SYDNEY NORTH PLANNING PANEL COUNCIL ASSESSMENT REPORT

Panel Reference	2017SNH001
DA Number	DA115/11/3
LGA	North Sydney Council
Proposed Development	Modification to DA 115/11 pursuant to S.96(2) including various changes to building layout and external configuration including building entry and basement changes, changes to approved RLs (no increase overall building height), facade and window changes and layout changes to all levels to facilitate increase from three (3) units over six floors to four (4) x 3 bedroom units.
Street Address	106 Kirribilli Avenue, Kirribilli
Applicant/Owner	AGA Project Control PO Box 20 VAUCLUSE NSW 2030
Date of DA lodgement	26 September 2016
Number of Submissions	Five (5) in support One (1) against (minor concerns)
Recommendation	Approval
Regional Development Criteria (Schedule 4A of the EP&A Act)	General Development (Ref CI 23G of EP & A Act & CI 21 SEPP State and Regional Development) 2011) Original Consent determined by Sydney East JRPP Capital Investment Value Exceeds \$10M as applicable to the originally approved development application.

Report prepared by	David Hoy, Team Leader Assessments
Report date	16 February 2017

S.96(2) MODIFICATION ASSESS

Figure 14: Extract of approved balustrade detail referred to in Condition A4.

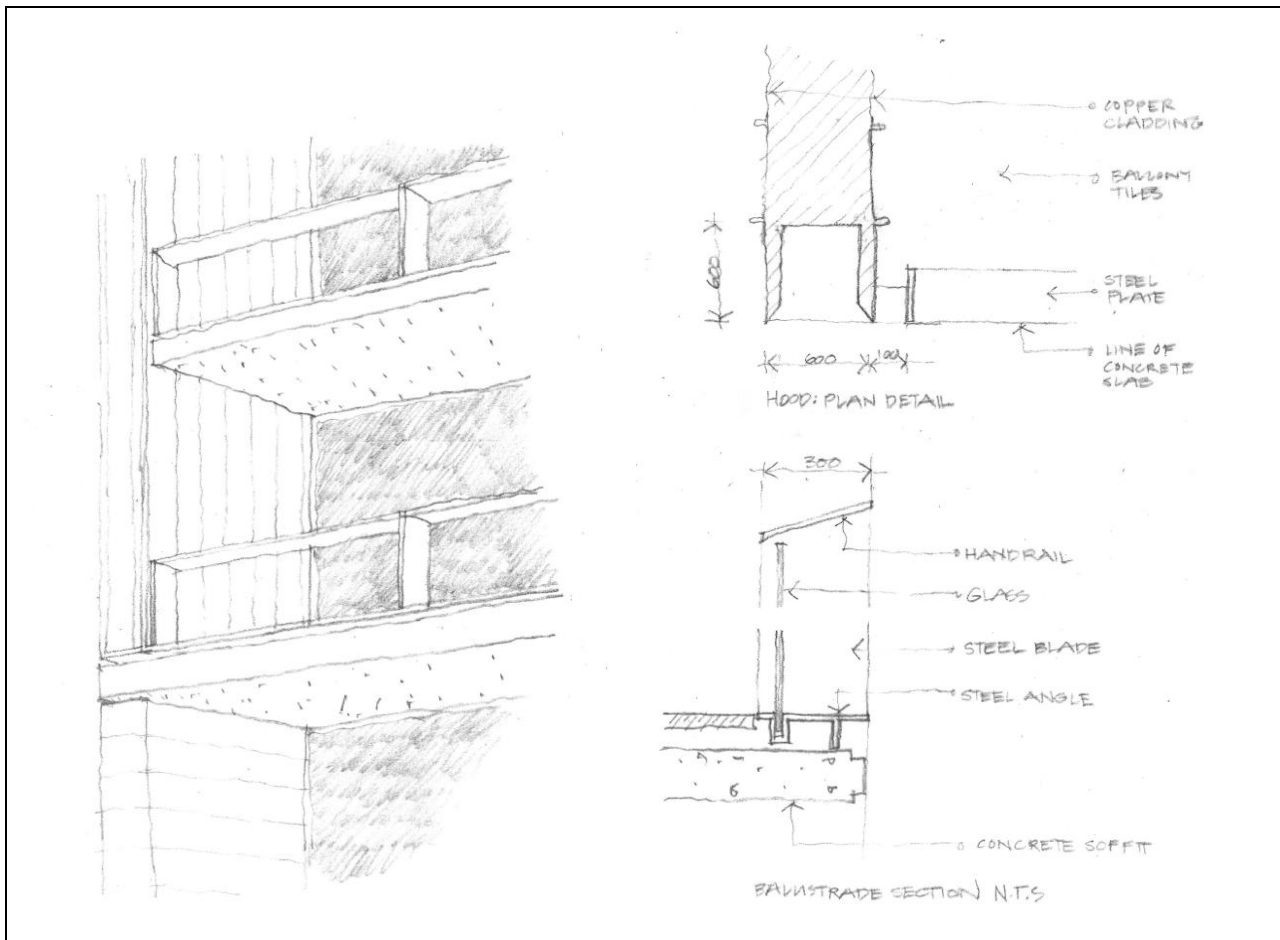
In relation to the approved balustrade design and nominated copper finish, Condition Nos. A4 was imposed in the original consent to ensure an appropriate balustrade design is provided to the southern elevation as shown in the approved sketch diagram below in Figure 14. The current modification incorporates façade changes which would still enable this balustrade design to be achieved. Amendment to the condition is sought by Council's Conservation planner to differentiate between the primary elevation and the Level 6 terrace

A4. Balustrade design for balconies to the front facade shall be in accordance with the detail submitted to Council on 17 November 2011, labelled Facade Detail Sketch dated 8 November 2011, by Tzannes Architects, except for Level 6. Details shall be submitted to Council's Conservation Planner, consistent with the detail provided on this plan shall be submitted to the Certifying Authority prior to the release of the Construction Certificate. Details of the balustrade design for Level 6 shall be approved in writing by Council's Conservation Planner, or suitably qualified conservation architect, and provided to the Certifying Authority prior to the issue of any Construction Certificate.

Figure 15 & 16: Approved and proposed landscape areas

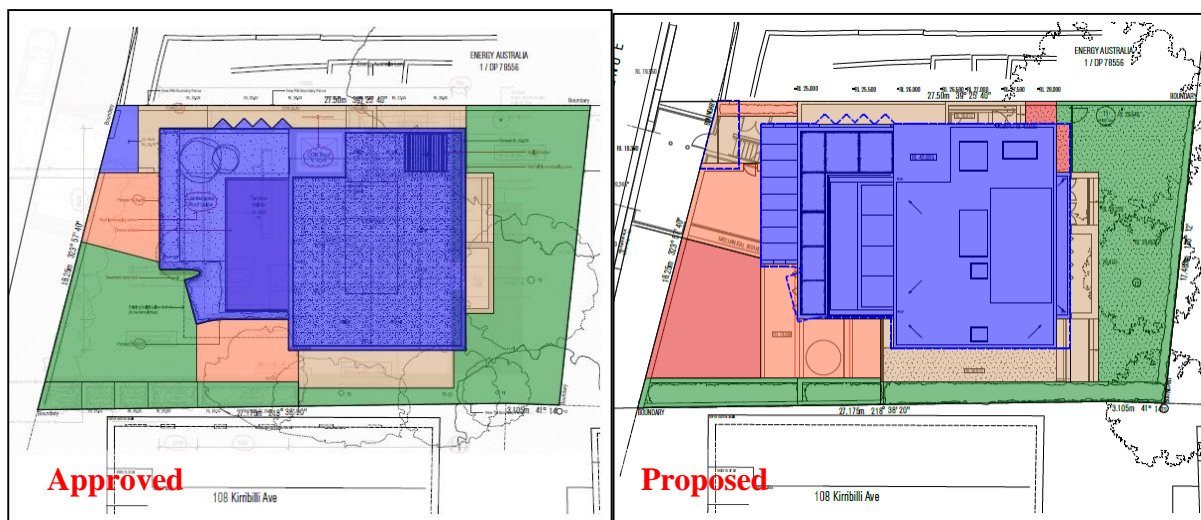
The proposed landscaped area is reduced from 186.2m² (36.9%) to 126.9m² (25.2%) as indicated in Figure 13 below. This is a substantial departure from the numeric requirements of Council's DCP provisions and significant reduction in overall deep soil landscaping from the approved scheme.

Roof Plan Proposed - Reductions shown coloured

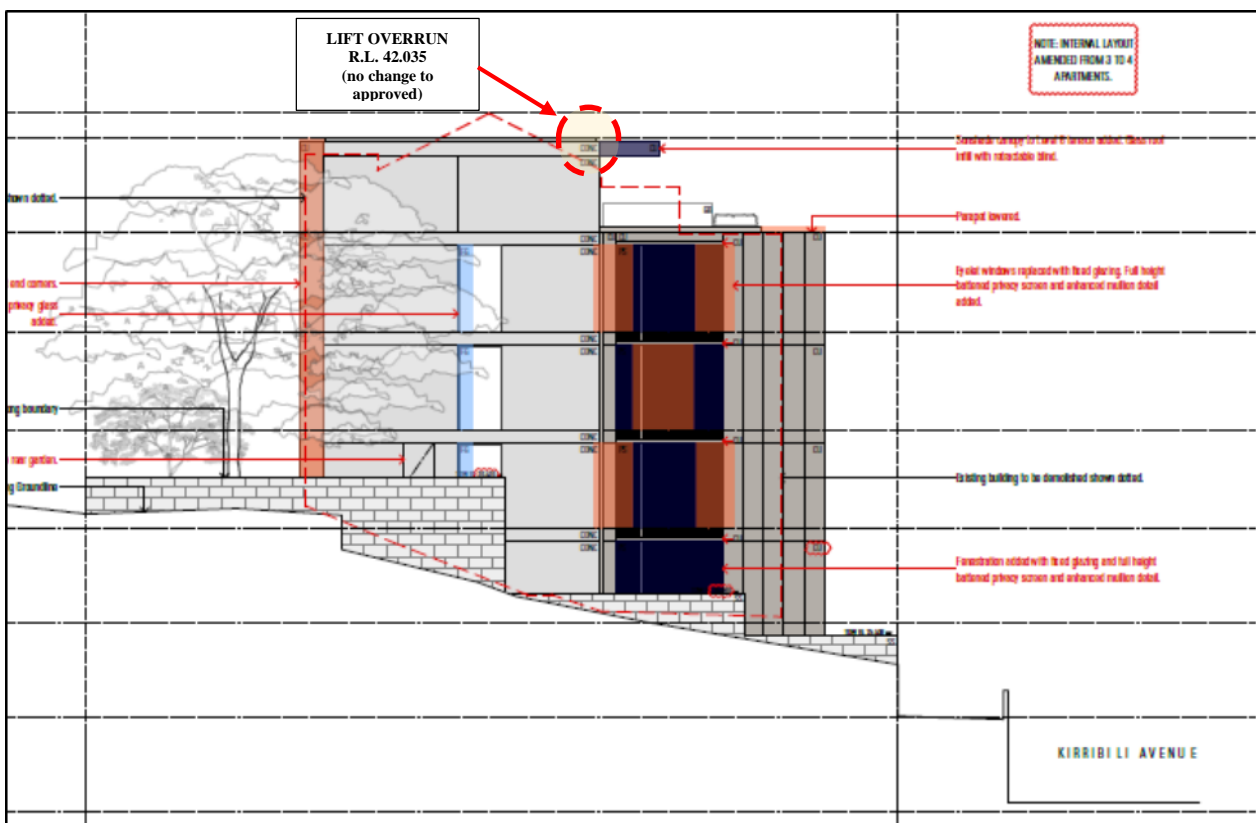
The primary issue raised by the submitter arising from the amendments was the potential erosion of existing views from your premises by the proposed awning to the Level 6 Terrace of the building and the "enclosure" of the terrace with glass. The proposed glass awning is open sided and not enclosed the glass balustrade is incorporated in the approved scheme. The current proposal would relocate the balustrade to reflect an amended layout for the trafficable area for the terrace. This would not further increase height of the development or additionally impact views from the adjoining property.

The proposed awning is a fixed structure with a glazed awning (roof) and a retractable blind which would extend 2.0m out from the approved roof to the top floor. It is a fixed structure and would generally be obscured from view from the submitter's property by the north-western corner of the lift overrun for the building which is slightly higher (as approved). This is best shown in the following extract diagrams.

additional adverse impacts would arise as a result of the proposed modifications. The view impact is deemed to be minor to negligible, however the applicant has agreed to accept a condition to delete the awning to the Level 6 terrace.

Figure 18: View Corridor – U8 65 Upper Pitt Street

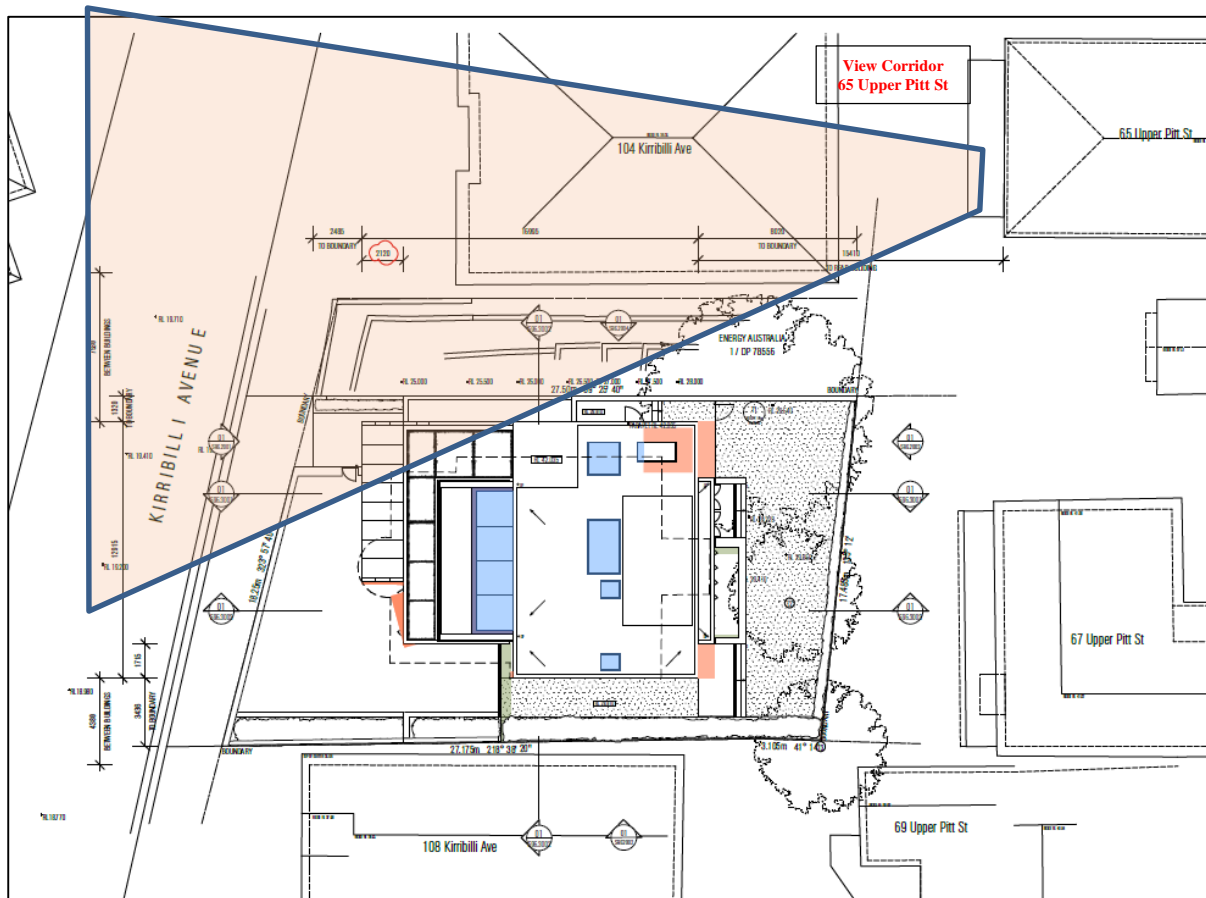
The concerns raised by the adjoining owners of **8/65 Upper Pitt St** have been considered in the assessment. The impact to existing view arising from the proposed modifications is assessed as low to negligible, with the modified development generally consistent with the approved development.
